Coming to Grips with -2p

Dave Dwelley
Linear Technology
Bonita Springs FL 9/15

V_{PORT PD}, V_{PD}: PD Input Voltage

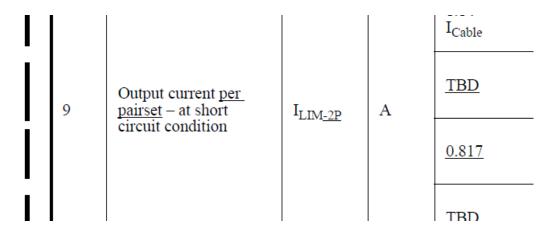
- This one is trickier since a dual-sig PD that draws unbalanced loads may see different voltages on each pair at the PD port
- Current language mixes V_{PORT PD}, V_{PD}, and V_{PORT PD-2P} liberally
- I suggest reverting to V_{PD} throughout and rewriting 33.3.7.1 and 33.3.7.4 to make clear that a dual-signature PD must treat each pairset independently see baseline text on p268
